### **OCTOBER 23, 2024**

### **ADDENDUM NO. 1**

HVAC UPGRADES – LAUDERDALE COUNTY ANIMAL SHELTER MARION, MS ERG P.N. 22.006

FIRST FLOOR PLAN -MECHANICAL

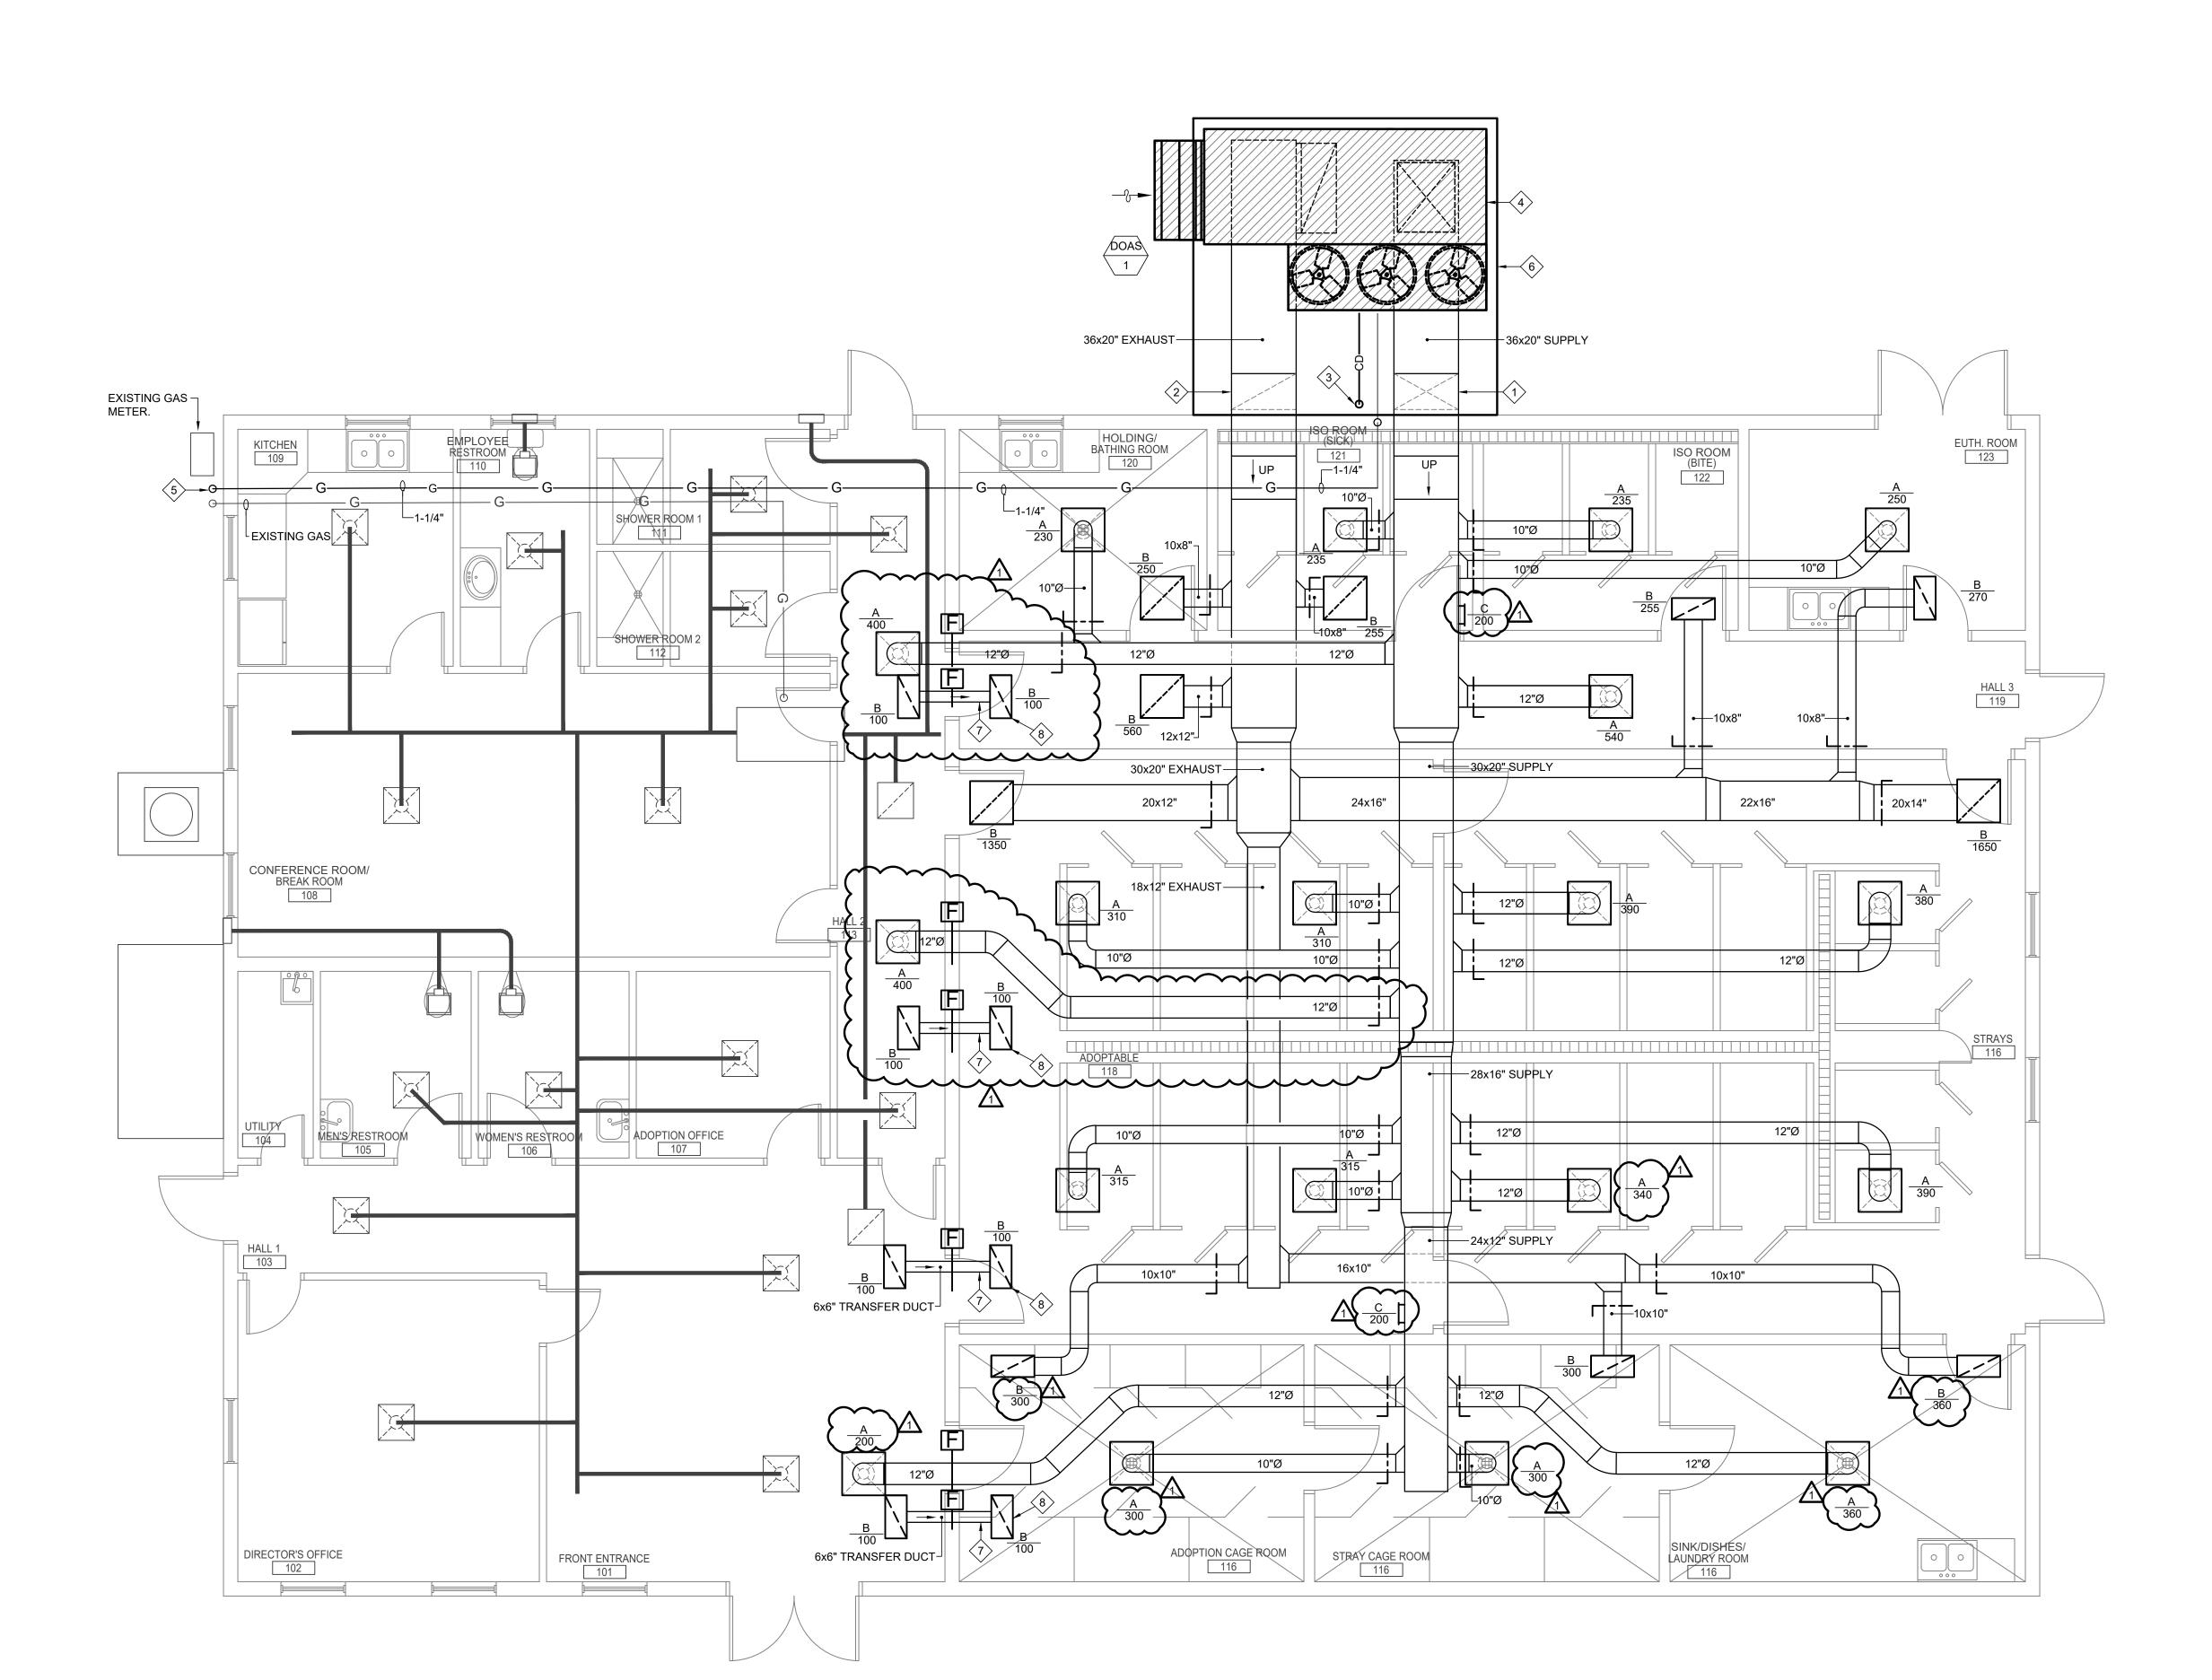
Item 3.	Reference:	Sheet T0.1							
	Scope:	Replace with attached Sheet T0.1							
Item 4	Reference:	Sheet G1.1							
	Scope:	Add the attached Sheet G1.1.							
Item 5.	Reference:	Sheet M1.1							
	Scope:	Replace with attached Sheet M1.1							
Item 6.	Reference:	Sheet M6.1							
	Scope:	Replace with attached Sheet M6.1
